**MEETING:** Site Review Committee  
**SUBJECT:** PKi3 Parking Lot Addition  
**ADDRESS:** 1150 Loudermilk Lane  
**PRELIMINARY SITE REVIEW**

**LOCATION:** Zoom  
**DATE:** March 10, 2022

RE: PKi3, LLC parking Lot Addition, Valparaiso, Indiana 46383

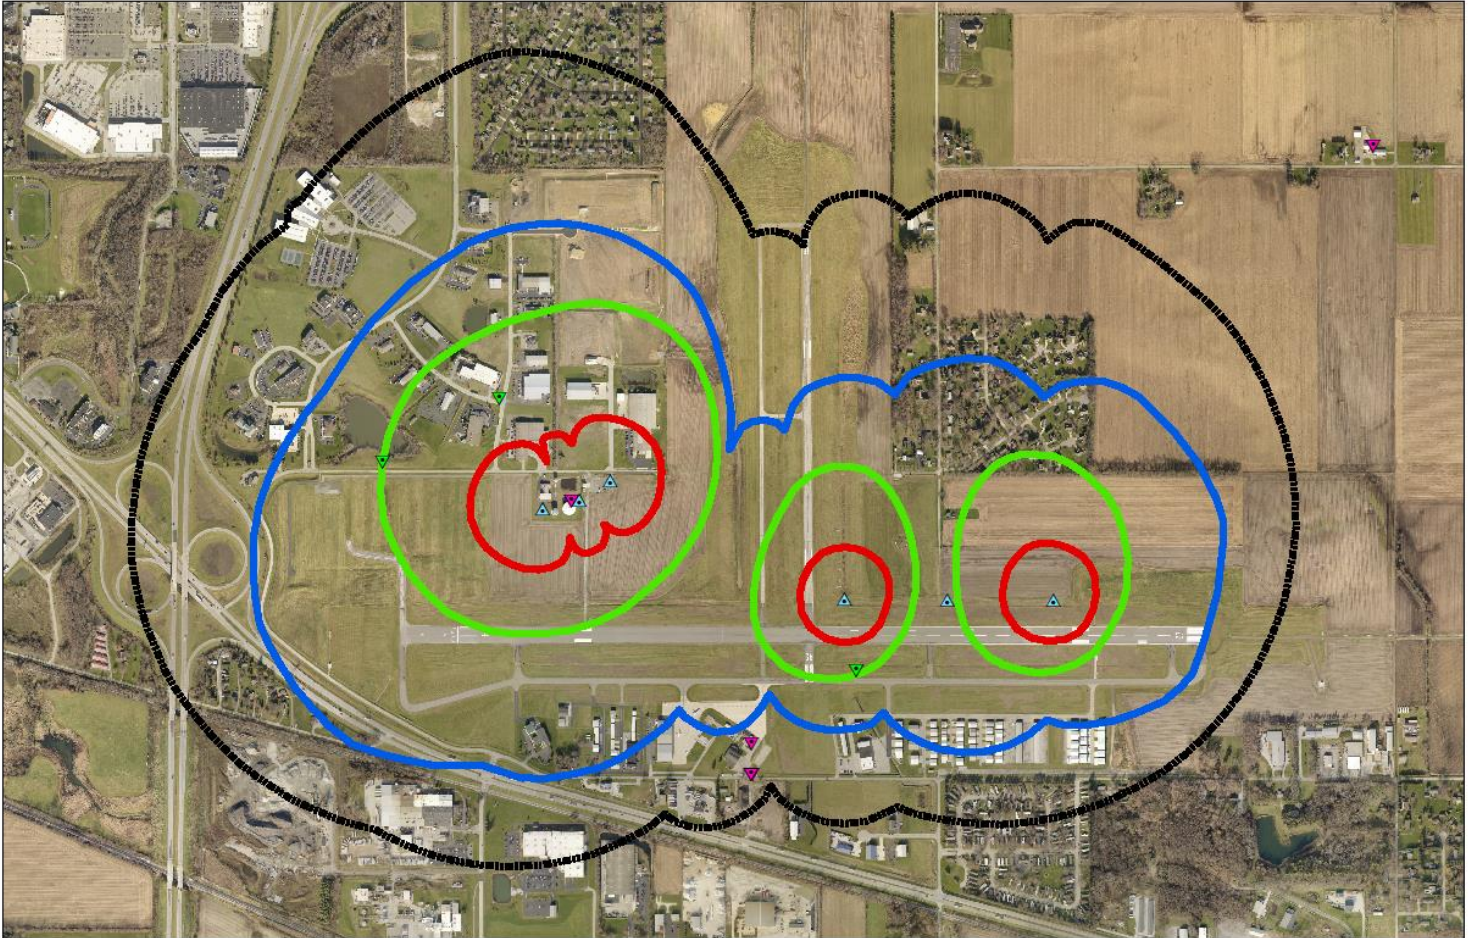
**ZURBRIGGEN:** Overall, what is being proposed looks good. Zurbruggen mentioned that he has the drainage report for the original lot. At one point this was a single lot. It was subdivided and replatted in 2008. He does have the drainage report for this. Zurbruggen indicated that he does have some drainage questions, but he will need to do a deeper review. Generally, Engineering is okay with what is being proposed. Zurbruggen suggested they meet to discuss drainage once he has been able to do a final review. DeBold indicated he will be available to meet and asked what the specific concerns might be and stated that most subdivision are pre-designed to handle the maximum impervious surface of the property. He believes this is the same since it went through review with the City and was approved. Zurbruggen explained it is more of a cursory concern to make sure we are matching what the pond was designed for and reiterated he has not had time to dive very deep into what it was exactly designed for, so it is more of just making sure we are hitting the standards that it was designed for. Zurbruggen mentioned that he will contact DeBold after the site review to setup a date and time to meet.

**LAIRD:** A Site Permit will be required. The Site Permit application will be submitted to the Building Department, but it will be approved by the Engineering Department.
